SUBJECT: NEW AUTOMATIC STRING ADVANCE FOR ST-40**AFFECTS:** ST-40 (UT-21511-B)

SUBJECT: NEW LEAF BAG A-01068 and LOCKING COLLAR 00909**AFFECTS:** HB-180V (STARTING WITH SERIAL NUMBER HK1210001)
A-00390-D & -E VACUUM KIT

SUBJECT: IMPROVEMENT TO MODEL 340 CHAIN SAWS**AFFECTS:** 340 (UT-10660-C)

BEARING RETAINER

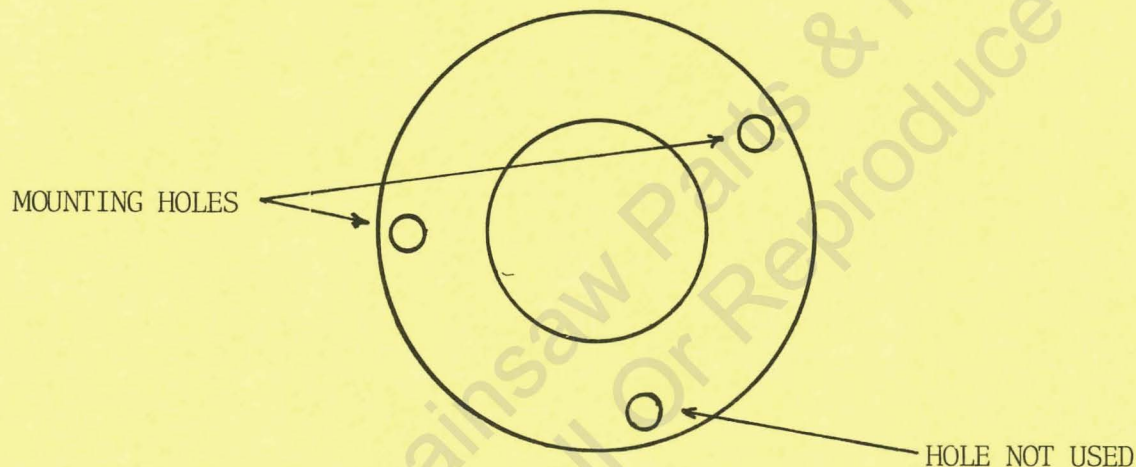
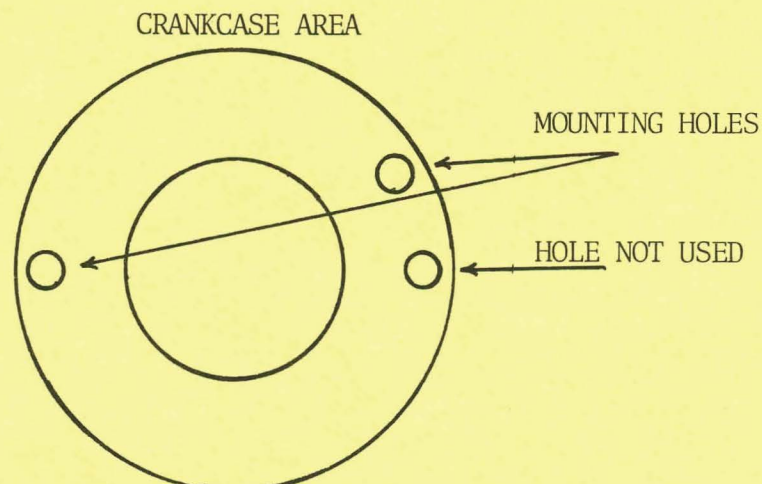
When ordering crankcase assembly (A-49771) for the above unit, there is confusion when it comes to mounting the bearing retainer. Some of the crankcases have three holes drilled in them as illustrated below:

One hole is located at the nine o'clock position. The other two are located at the 2:30 and 3:00 o'clock positions respectively.

When installing the bearing retainer use the gasket and plate supplied. You will find that two of the holes in the plate match the holes at the 9:00 o'clock and 2:30 o'clock positions. Disregard the third hole in the plate. IT IS NOT NEEDED.

The two mounting holes are located 165° apart and will hold the plate down sufficiently to retain the bearing and seal the crankcase.

SUBJECT: CHANGE, STARTER BUSHING**AFFECTS:** XL, S-2, 240, 330 CHAIN SAWS

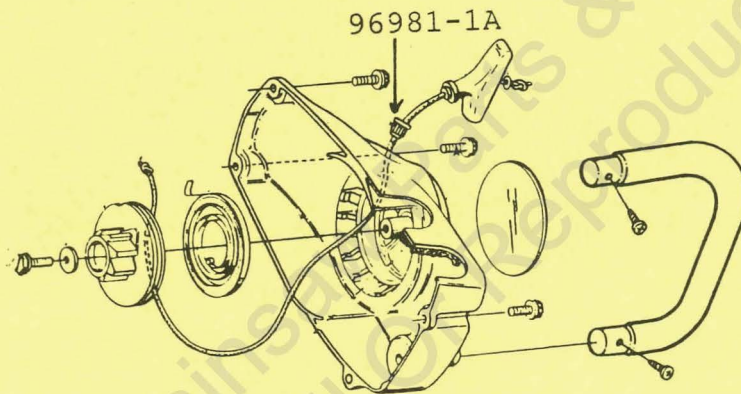
The steel bushing, part number 96981-1A has been removed from the starter housing on the above saws. There have been numerous reports of this bushing vibrating loose.

This bushing is being replaced by a Brass eyelet, part number 03015. The brass eyelet will be pressed in and flared at the factory and will not be replaceable in the field.

Old Pump
(A-02944)

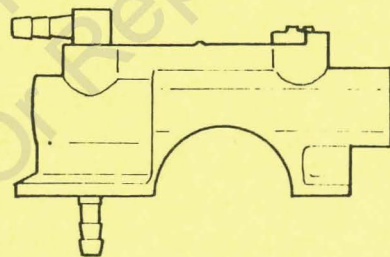
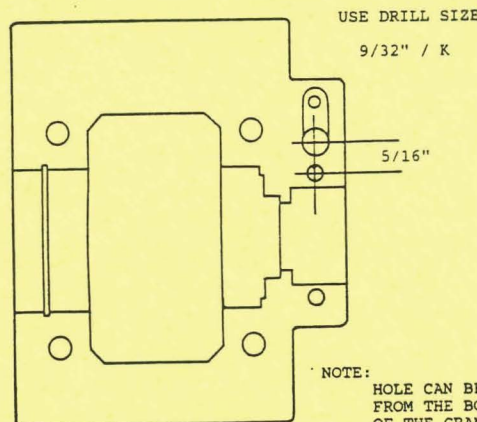
The oil pump (A-02944) has been changed to (A-02802-A). A fitting for the oil line has been installed in the new pump. The (01806-A) rubber gasket will no longer be needed.

When installing the new oil pump on early production saws (before HL2130521), the crankcase will need to have a hole drilled in it so that the fitting will be able to go through for the oil line. The following drawing will give you the location and size of the hole to be drilled.

NOTE: Remove old fitting from crankcase and discard.

NOTE:
HOLE CAN BE DRILLED FROM THE BOTTOM SIDE OF THE CRANKCASE. CRANKCASE DOES NOT HAVE TO BE TORN APART.

SUBJECT: OIL PICKUP LINE**AFFECTS:** S-1050 CHAIN SAW

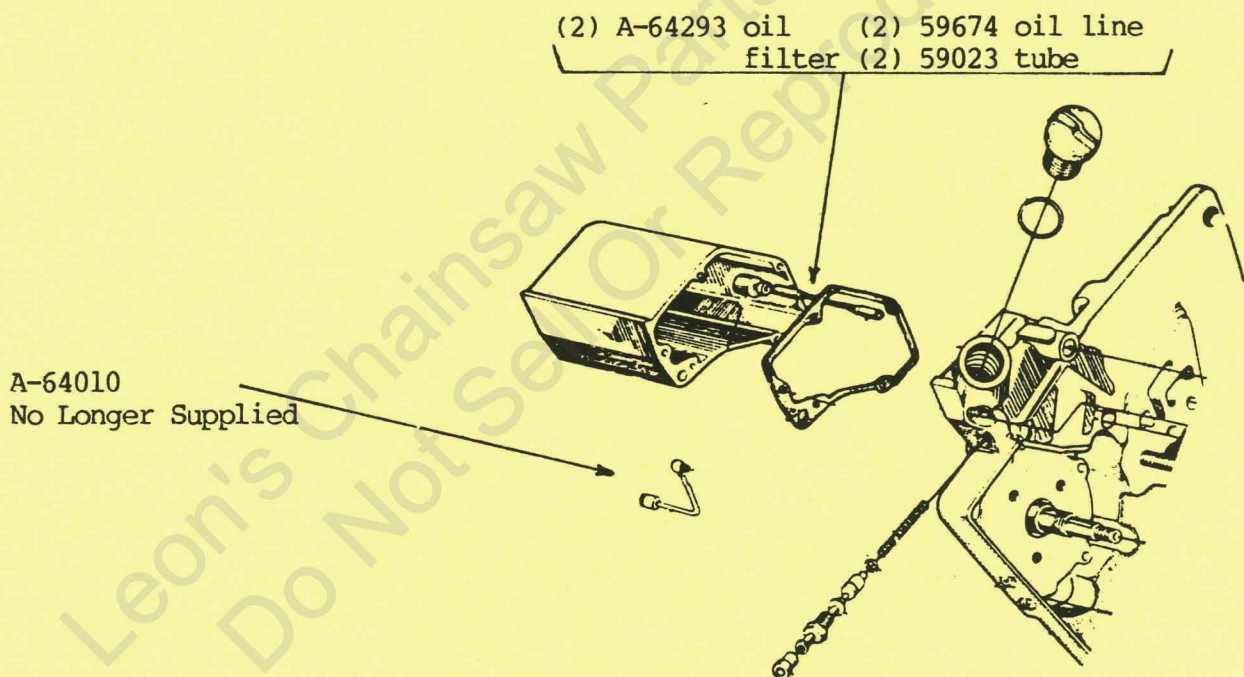
When replacing the oil pick up line and filter for the manual oiler you will have to remove the 90° fitting on the drivecase (64011) and replace it with a straight tube (59023).

The A-64010 oil pick up line will no longer be supplied. By replacing the fitting in the crankcase you can use the A-64293 oil filter and 59674 oil pick up line to service the oiler

Each unit will now use two of each A-64293 oil line, 59674 oil line, and 59023 tube. One set for the manual oiler and one set for the automatic oiler.
